**City of Portland, Maine - Building or Use Permit Application** 389 Congress Street, 04101, Tel: (207) 874-8703, FAX: 874-8716

Location of Construction: 621 Island Ave, Peaks Island		Owner: Maybelle & Mark Craenick	Phone: 775-0391	Permit No: <b>001204</b>
Owner Address: 17 Kenwood St. Portland, ME 04102		Lessee/Buyer's Name:	Phone:	BusinessName:
Contractor Name: Longelle-Construction		Address:		Phone:
Past Use: <i>Langella</i> Single Family		Proposed Use: Single Family	COST OF WORK: \$21,500.00	PERMIT FEE: \$156.00
Proposed Project Description:  Demo of porch; build new porch, roof, & shed		FIRE DEPT. <input type="checkbox"/> Approved <input type="checkbox"/> Denied		INSPECTION: Use Group <i>R-3</i> Type: <i>59</i> <i>BOCAGG</i>
		Signature:		Signature: <i>Hoffman</i>
PEDESTRIAN ACTIVITIES DISTRICT (P.A.D.)		Action: <input checked="" type="checkbox"/> Approved		Zone: CBL: 092-E-018
		Approved with Conditions: <input type="checkbox"/>		
Signature:		Denied: <input type="checkbox"/>		Zoning Approval: <i>OK with conditions</i> <b>Special Zone or Reviews:</b> <input type="checkbox"/> Shoreland <input type="checkbox"/> Wetland <input type="checkbox"/> Flood Zone <input type="checkbox"/

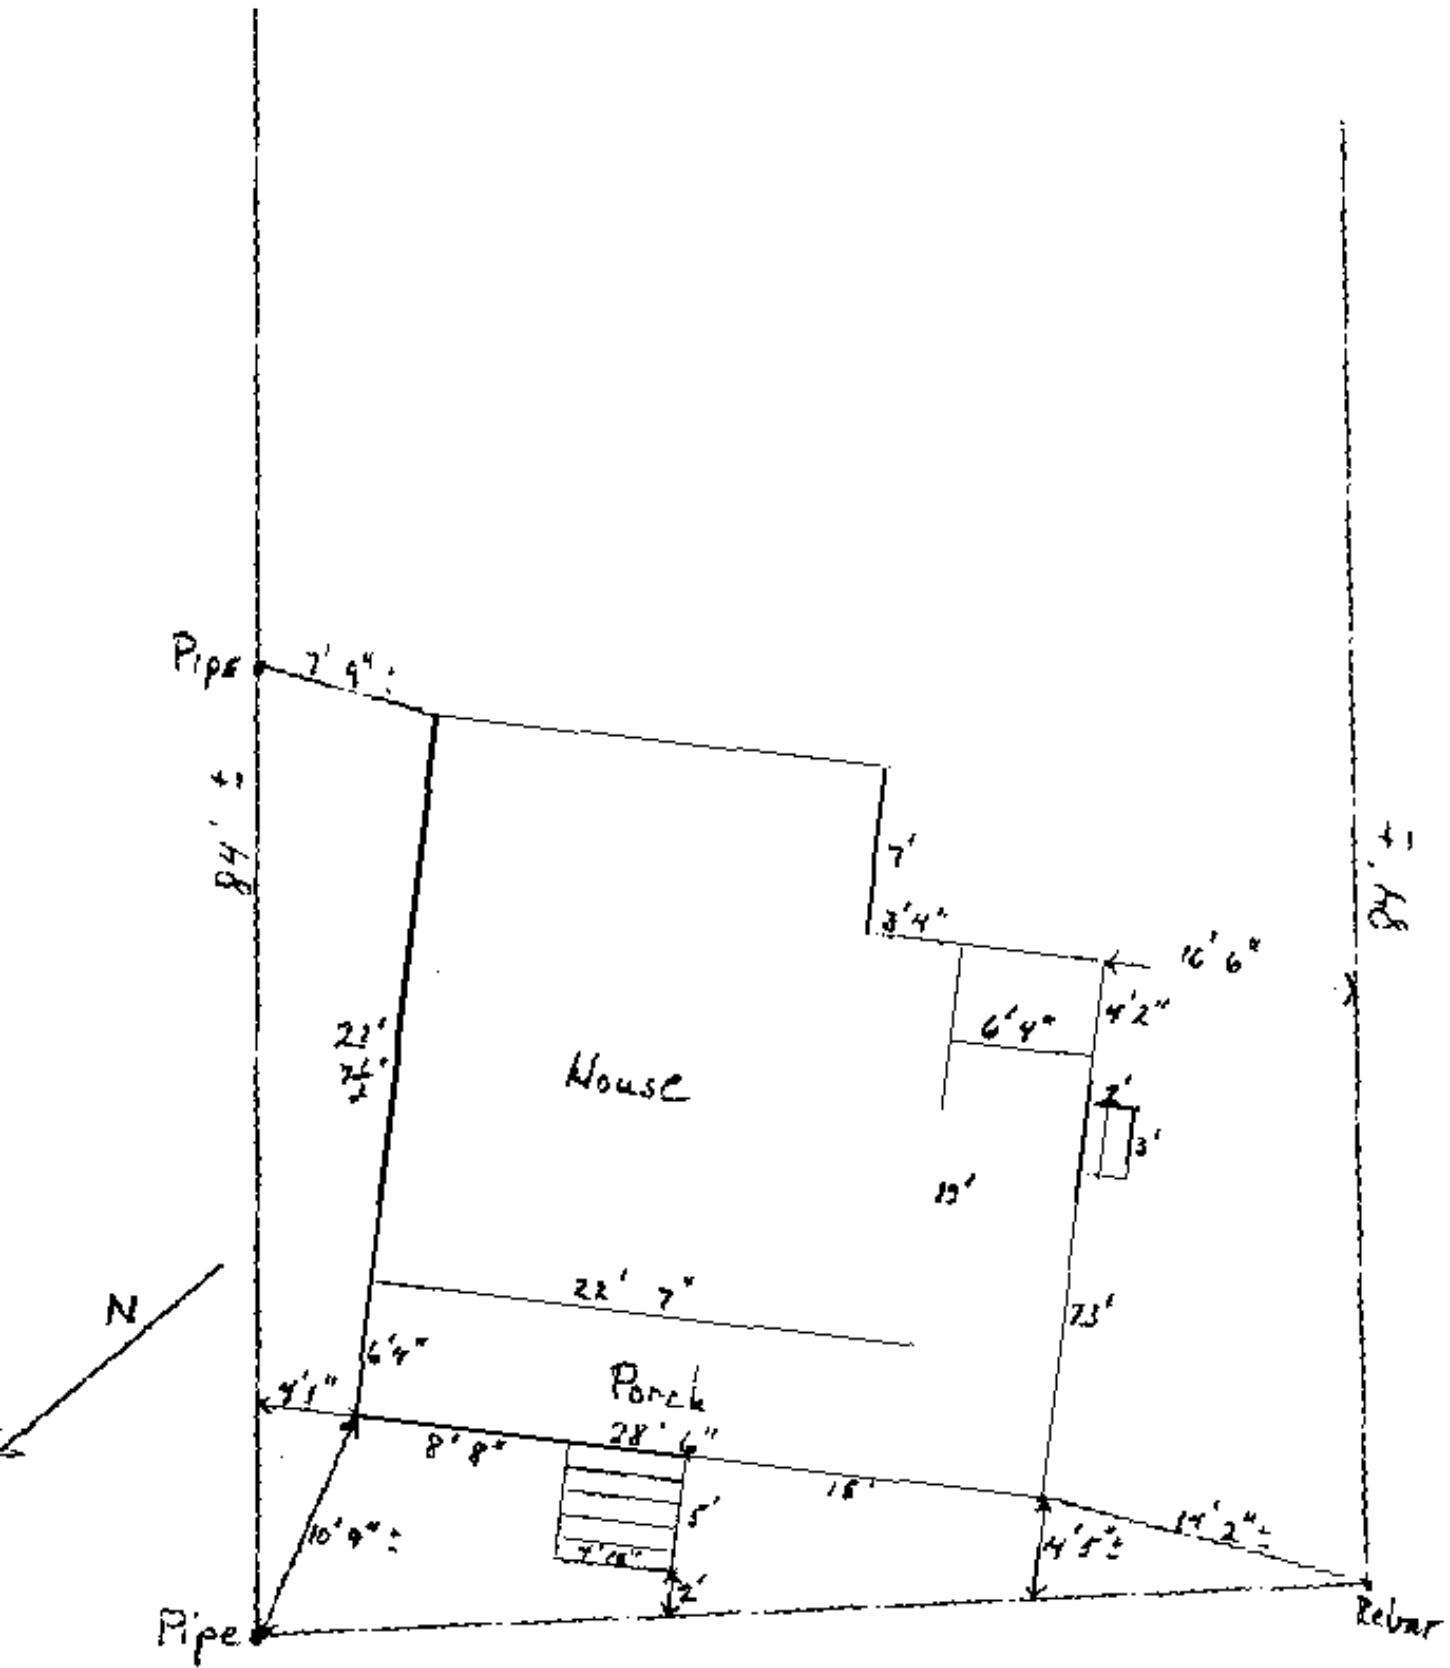
All is existing according to the  
Contractor Agreement -  
There shall be no increase in  
the existing footprints -  
see condition
